# 616 APARTMENTS

SDCI Project #3020991-LU

BRIEFING PACKAGE  
ISR Board

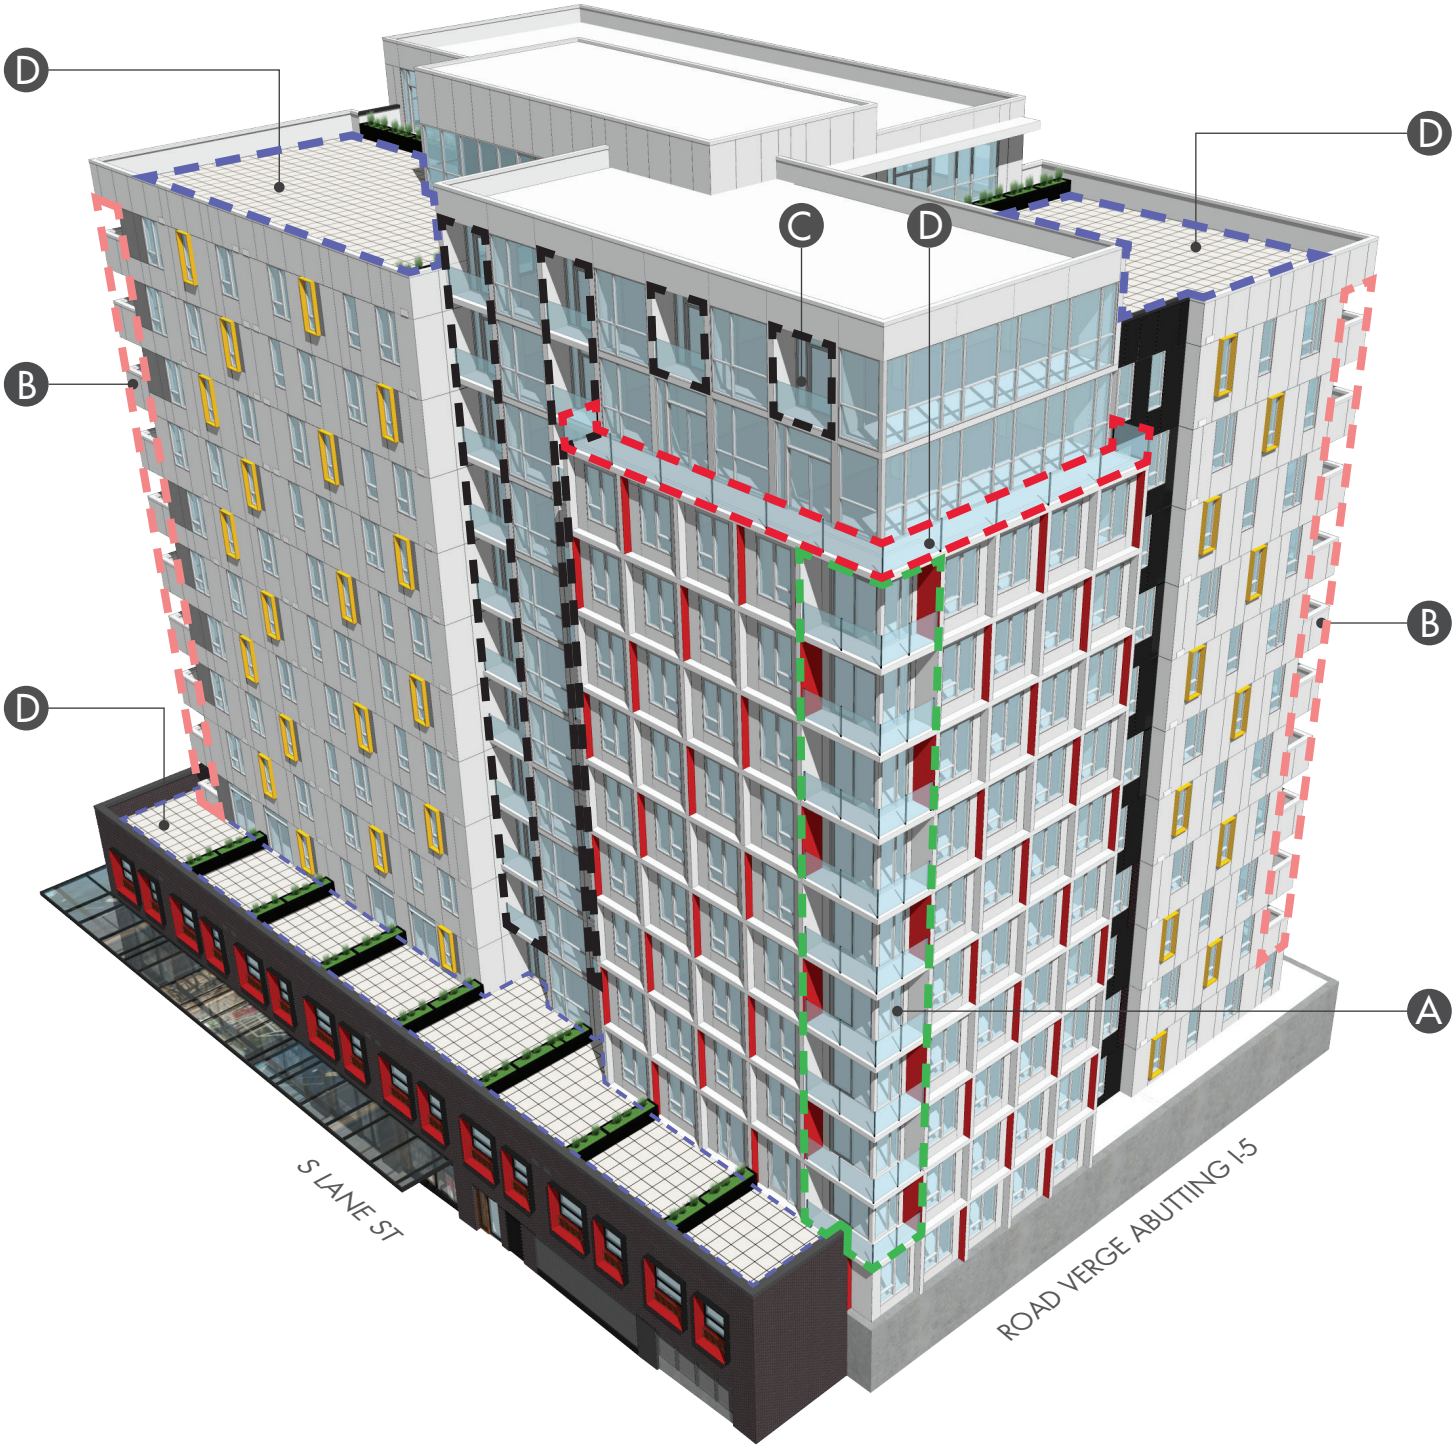
2. The Board recommended adding on decks/ balconies and focusing on deck assembly in regard to texture, scheme, and interesting elements.

The design has been refined and includes many types and scales of decks, patios and terraces around the building that include various textures, materials and finishes in order to add to the modulation of the façade as well as allows users of the spaces area for outdoor living and enjoyment.

FAÇADE TREATMENTS

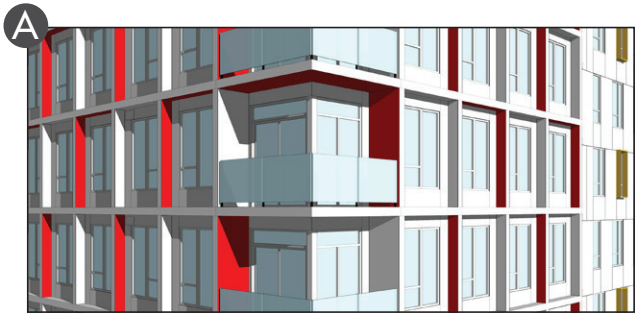
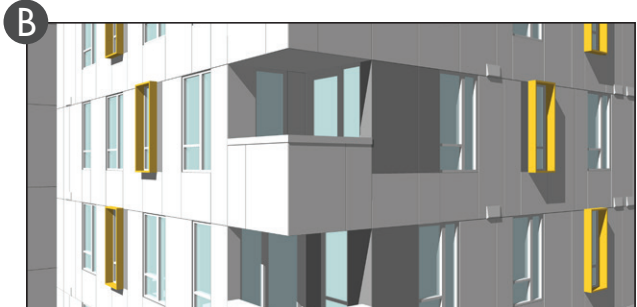
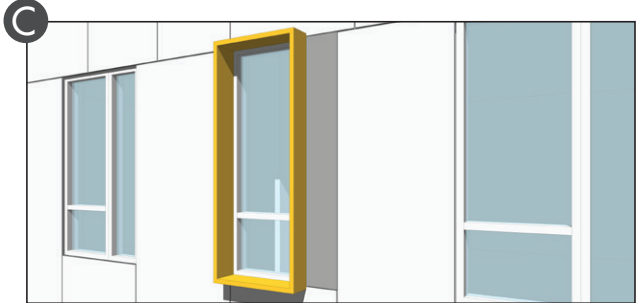
3. The Board desired to see further modulation on the north façade as it demonstrated a highly visible elevation.

In response to the Board’s comment, the design of the North façade has been further refined to include the following:

- A. Corner balcony has been added to breakdown the massing and provide outdoor living space. It is designed with a glass railing to match adjacent façade treatments.

- B. Another corner balcony has been added to the east side of the façade as well to break down the massing and perceived scale of the building, as well as provide outdoor living space. This design feature includes a solid parapet railing that will match the adjacent siding material.

- C. Colored shadow boxes have been added to the east portion of the façade to break down the massing and add color to the façade as well. These will protrude past the windows and create shadow lines around the perimeter of the box.

- D. The majority of the windows on the west side of this façade have been recessed to provide additional shadow lines and interest to the façade. Colored panels have also been added in these locations to express the recessed windows even further.

- E. Floor to ceiling glazing has been added to the upper levels to bring down the scale of the upper floors by providing a material that is transparent and not solid. The windows will help with the perceived mass along this façade as well as allow for great views of the City from these units.

FENESTRATION PATTERNS

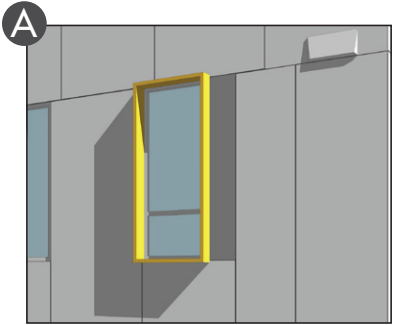
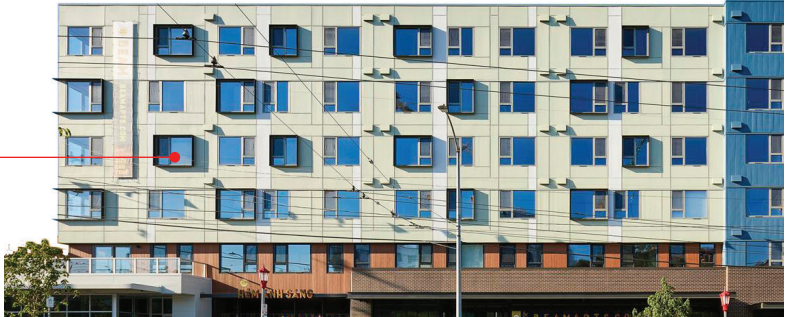
4. Some Board members noticed the repetitive window pattern and suggested referencing the fenestration of the CID in order to strengthen the connection with the surrounding context.

The design have been developed to strengthen the connection with other buildings in the CID per the Board’s comments. The podium base of the project includes a brick façade, which is found throughout the CID, especially in older buildings, but is also found in newer projects in the neighborhood. Along with the brick façade, the street level façade has many larger storefront windows that open up to the street and provide opportunities for retail development along both street fronts. The retail spaces are designed so that they can be developed into smaller shops, which is similar to other spaces in the CID. Above the brick in the podium levels are punched windows, typical of what can be found in the neighborhood, as well as perforated art screens that will provide further interest along the façade at the lower levels where pedestrian activity is seen. On the upper levels of the building there are shadow boxes around some of the windows that are similar to other newer projects in the neighborhood. These will also provide interest and texture to the façade on the upper levels.

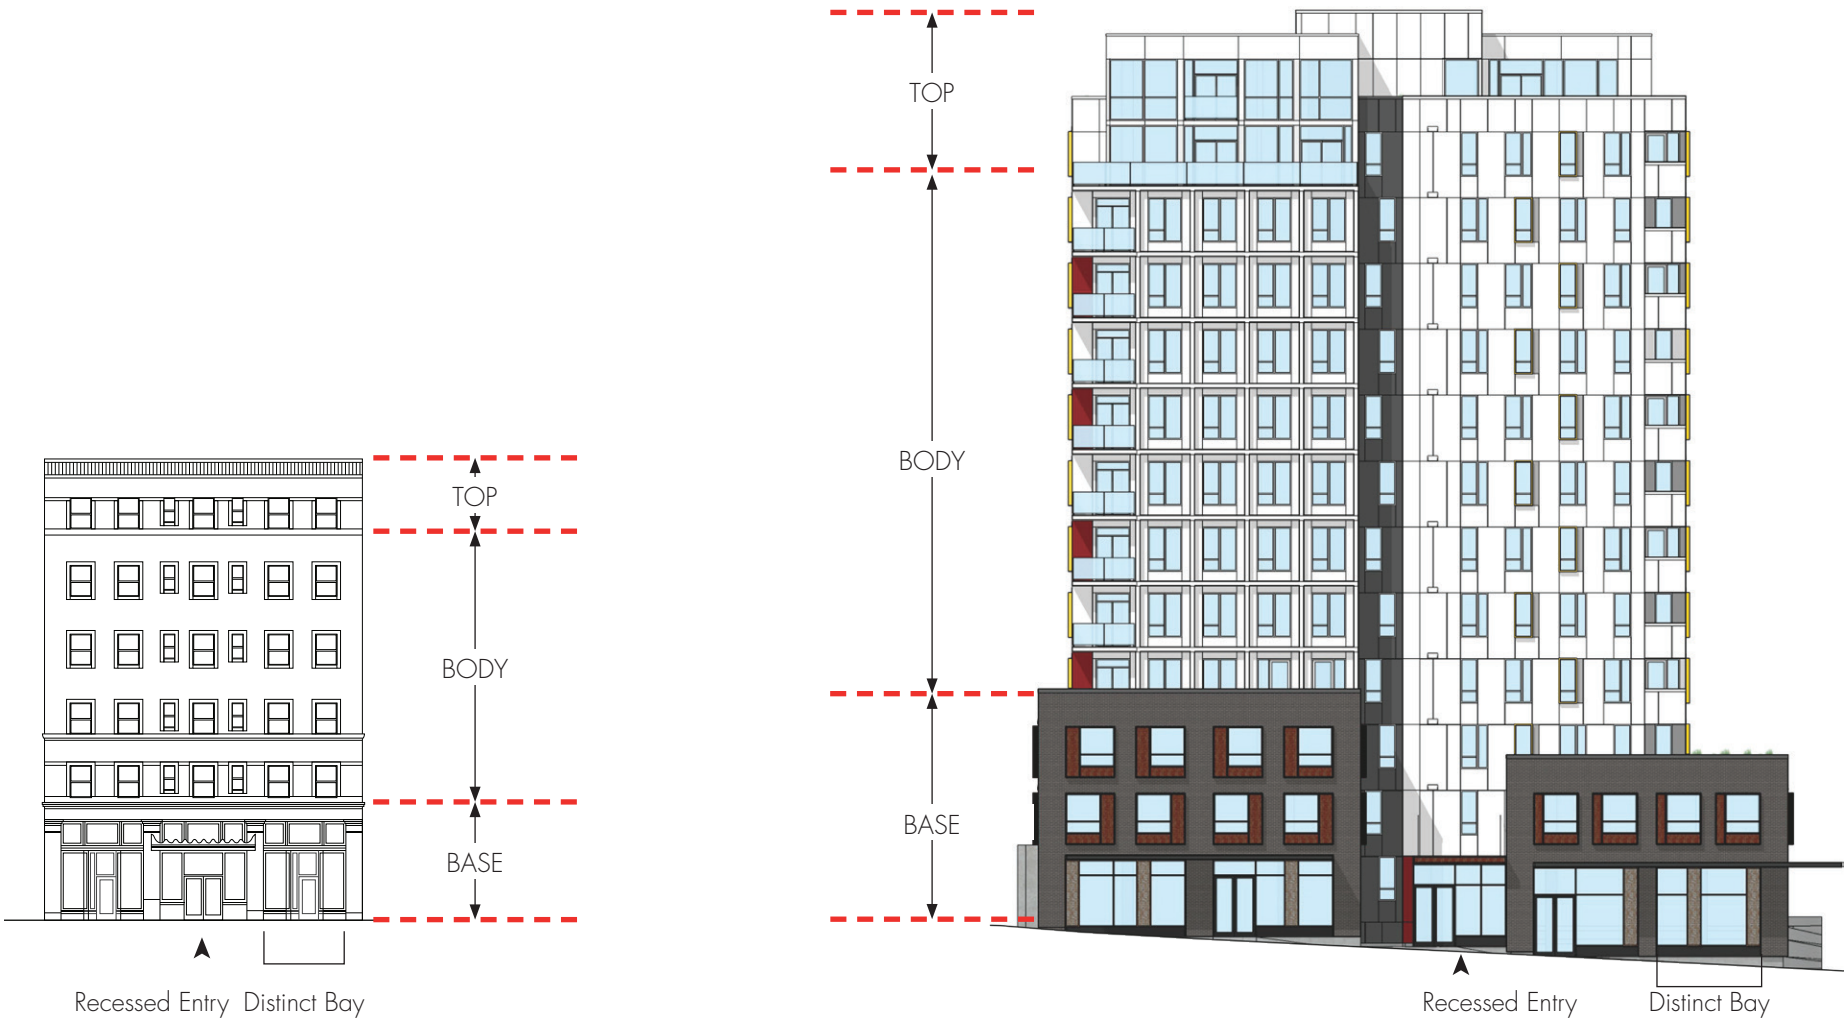
5. The Board requested an exploration of architectural elements referencing the characteristics of buildings in the CID, focusing on creating a “neighborly feel” that can enhance the visual order and compatibility with the surrounding buildings. The Board stated that the west face of the podium of Scheme 2 demonstrated a strong correlation with the neighborhood.

- 1. Respect and following the same framework and order set by the classic precedent buildings in the CID: the base, the body and the top.
- 2. Set the podium height in response to datum lines of the sounding buildings or podium heights.

- 5. Provide public plazas/open space at the street corner and the apartment entry. Activate sidewalks and open spaces with pedestrian- oriented features, such as decorative pavement, planting strips with seating and decorative streetlights, which all encourage walking, sitting and other activities.

- 6. Incorporate design elements such as the perforated art panel, the extruded metal shadow box at the windows with accent color and decorative pavement, to pay tribute to the history and culture of the CID and provide opportunities to infuse public art in the building design.

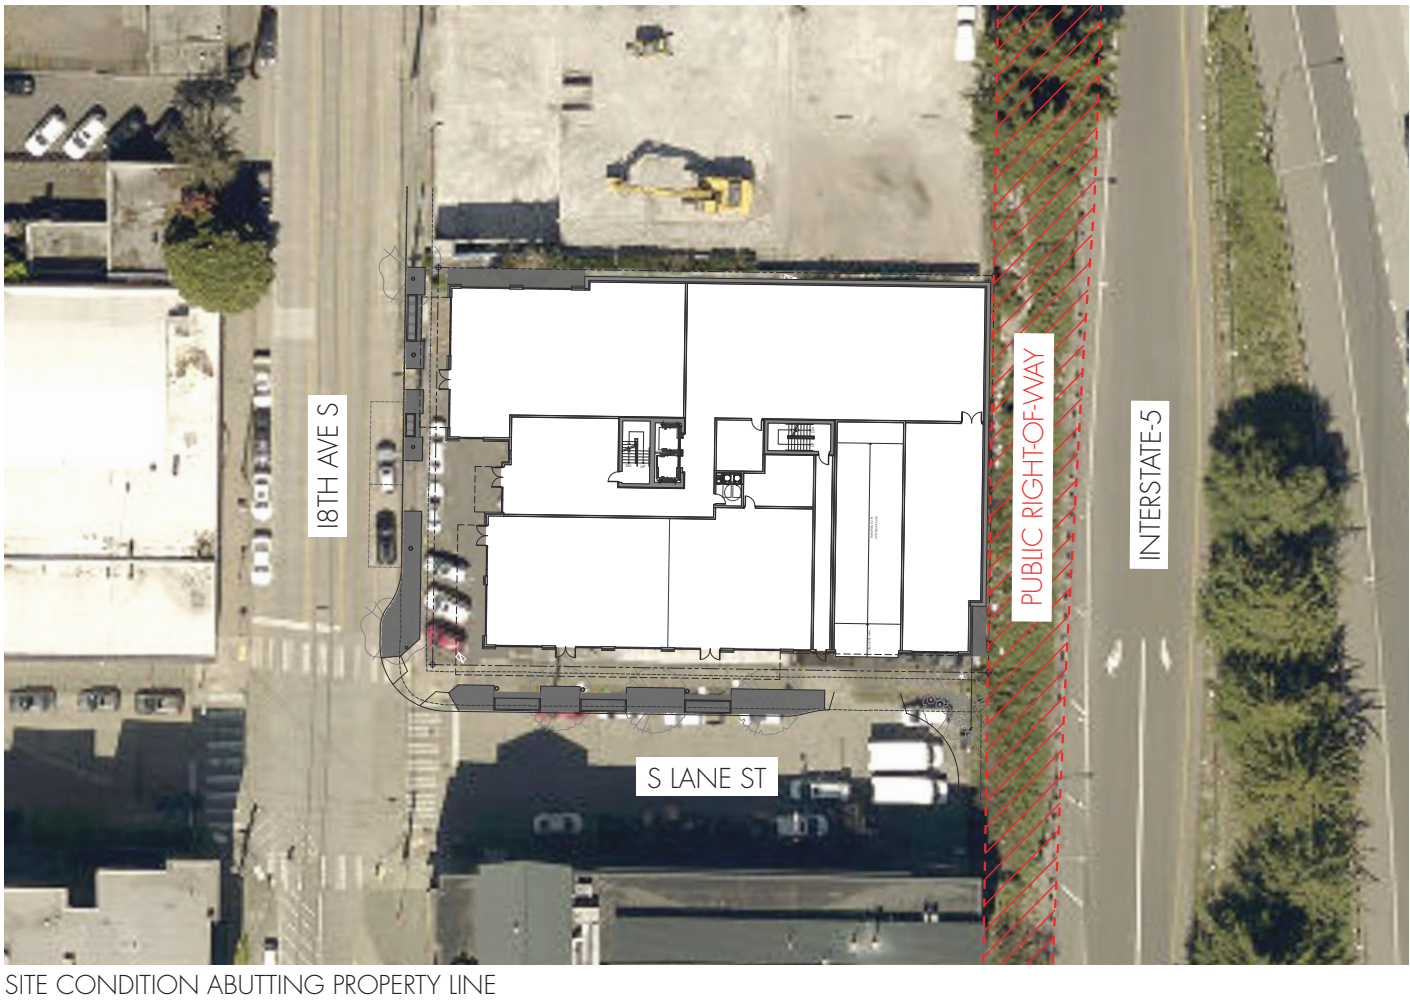
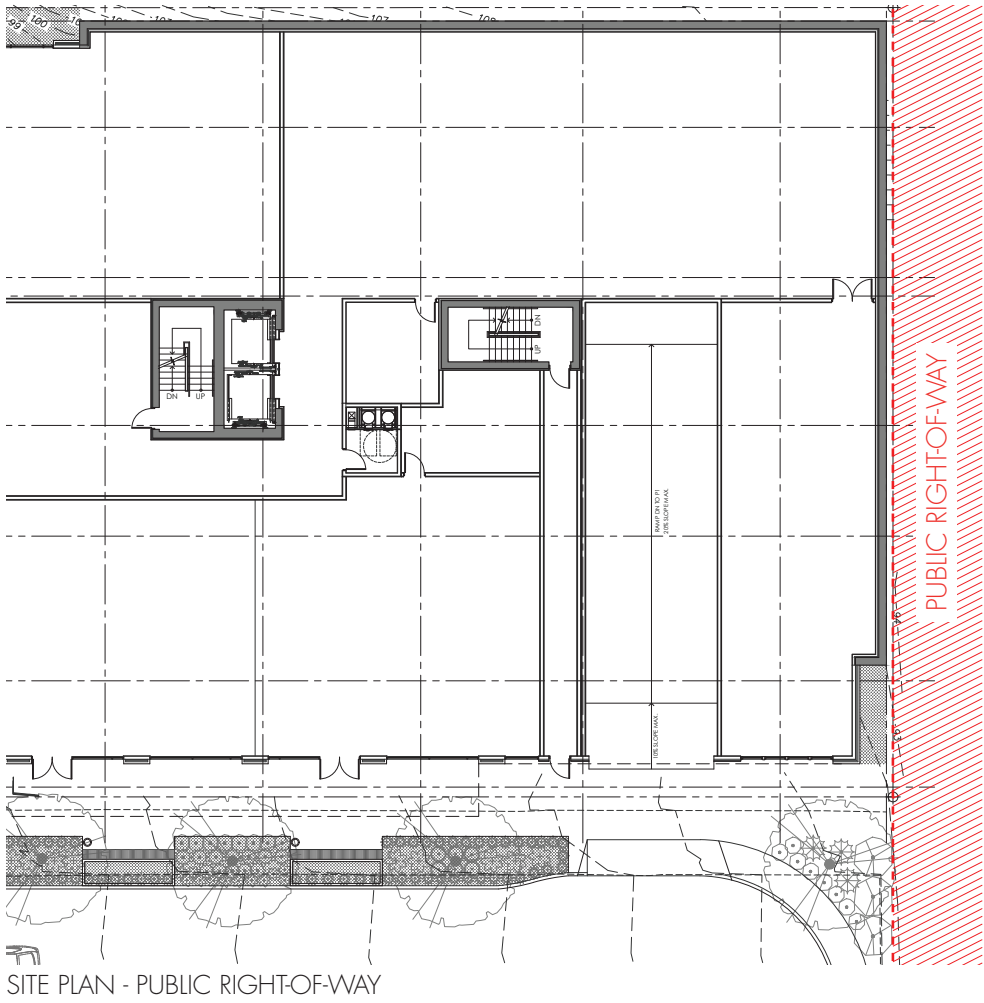
8. Some Board members reminded the applicant that they expected to see an east rendering and expressed concern about safety at the east face considering the site condition abuts the property.
